**AGENDA
BOARD OF ADJUSTMENT
REGULAR MEETING
DECEMBER 18, 2024
5:00 PM
CITY HALL COMMISSION CHAMBERS
204 ASH STREET
FERNANDINA BEACH, FL 32034**

Project Type	Site Plan Review
Project Name	3rd and Beech Multifamily Condo
Proposed Access Road	Beech Street and South 4th
Rd Maintenance Jurisdiction	City Maintained
Project Estimated Cost	350000
Description of Request	Construction of 2 (two) two-story triplex units and a four-story, 29-unit residential condominium and apartment building
Site Plan Review Checklist	<i>Field not completed.</i>
School Concurrency	<i>New residential development is required to demonstrate compliance with school concurrency as regulated in the City of Fernandina Beach through the City of Fernandina Beach's Comprehensive Plan Intergovernmental Coordination Element and the Interlocal Agreement Amendment for Public School Facility Planning adopted by the City on May 21, 2019. No new residential rezoning, preliminary plat, site plan or functional equivalent may be approved by the City unless the residential development is exempt from requirements outlined in Section 9.13 of the Amended Interlocal Agreement OR a School Concurrency Reservation Letter has been issued

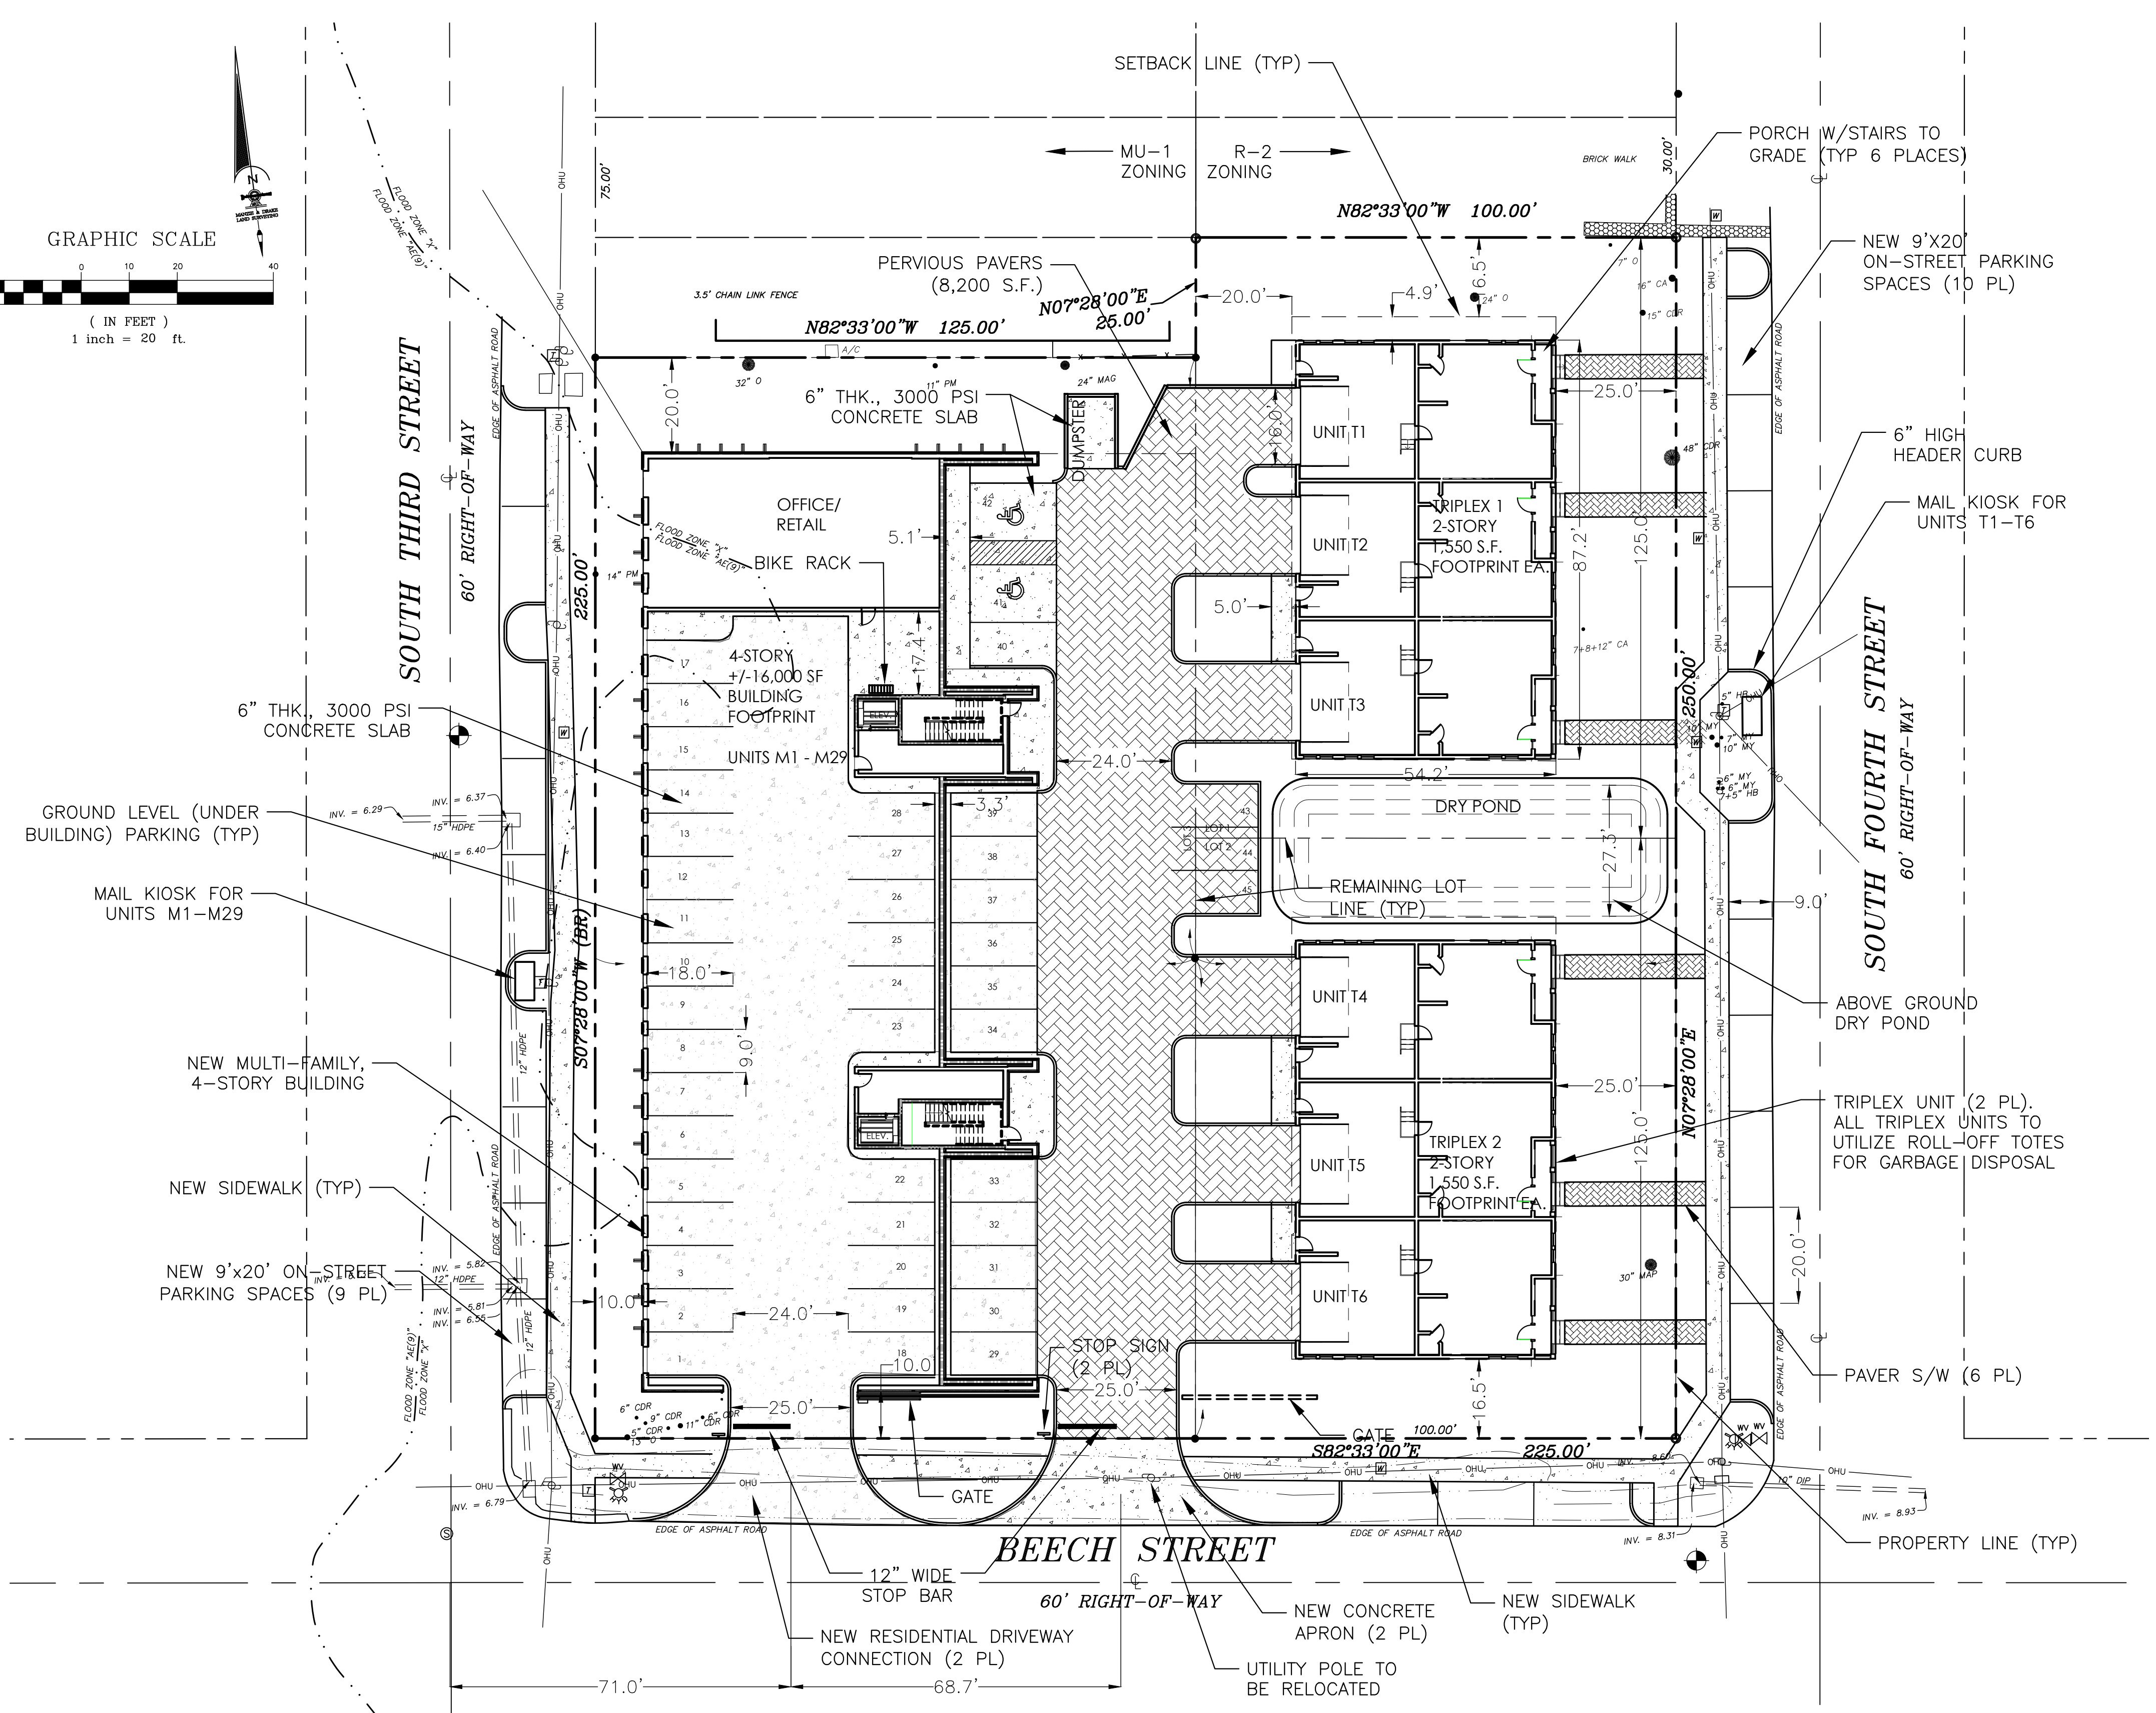
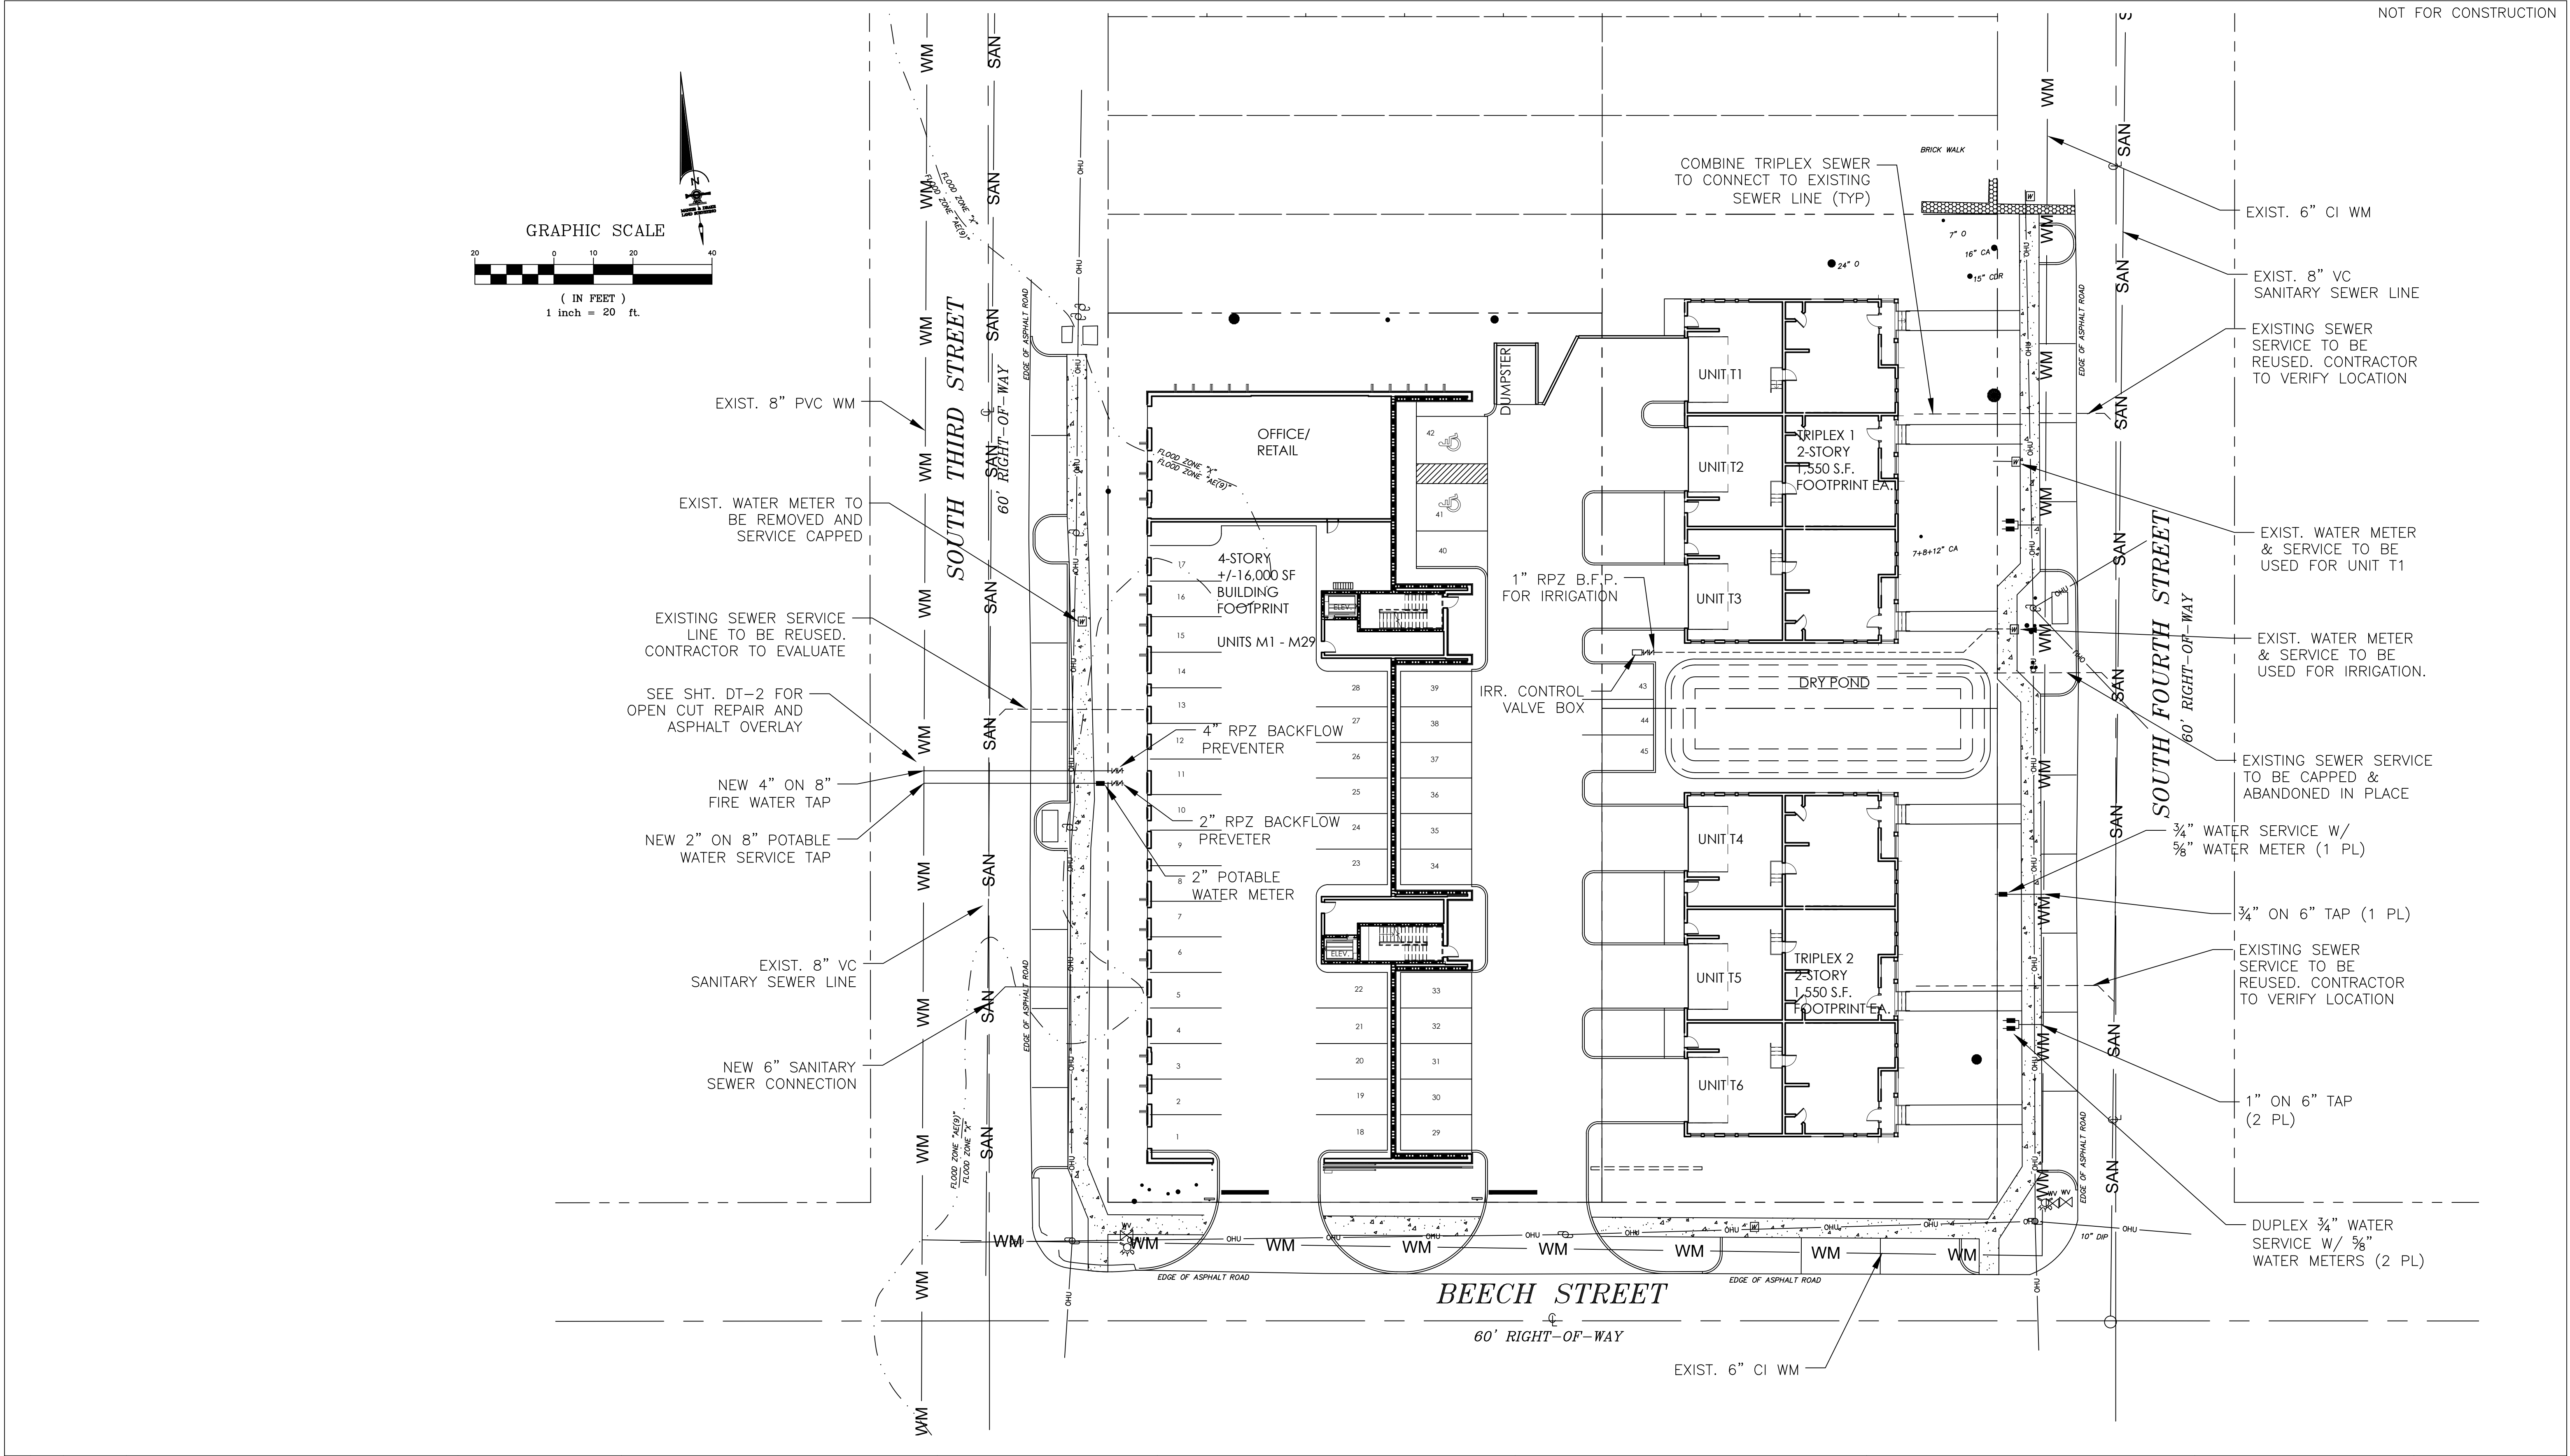
Live Local: Can you provide a calculation of total number of units being qualified under the Live Local Act? 40% minimum. Affidavit required, **see attached**.

Please see Sheet GE-1. Affidavit to come from the owner.

REGISTERED DESIGN PROFESSIONAL	Date: 10/9/24
Project No. 24-10-XX	
Sheet: DR-1	
Page 6 of 12

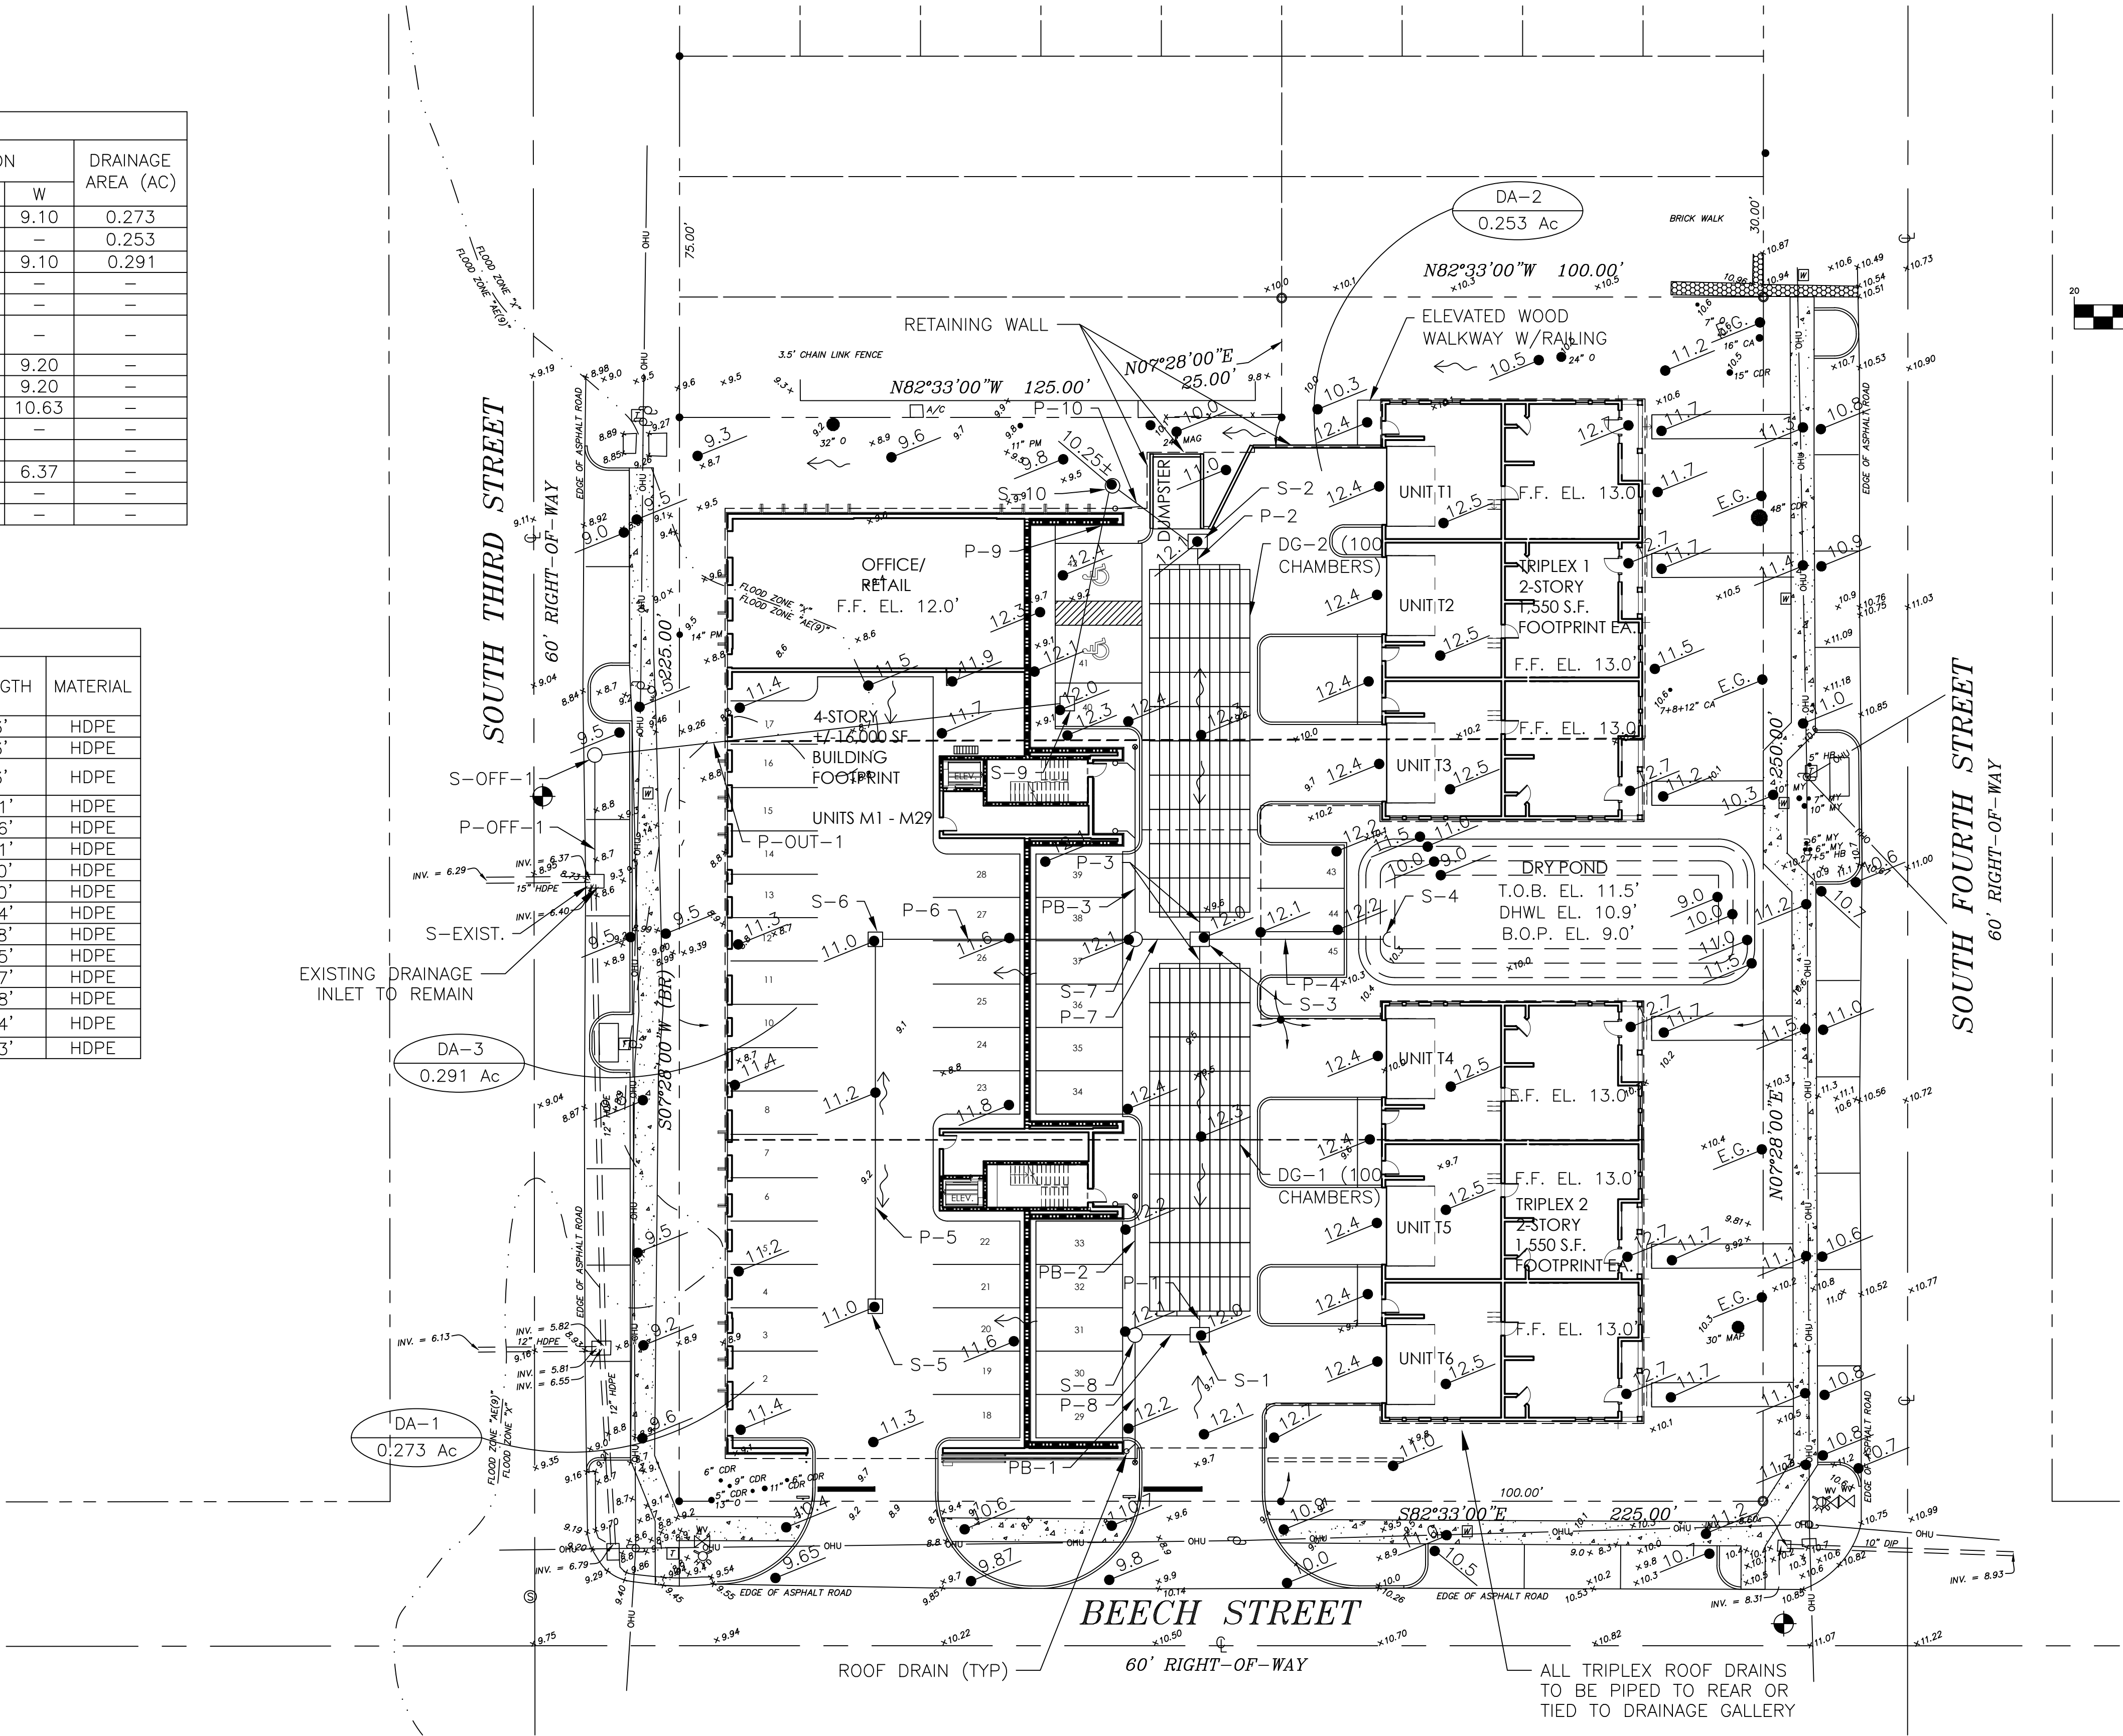
- **Please provide details of grading.**

Additional grading is shown on Sheet DR-1
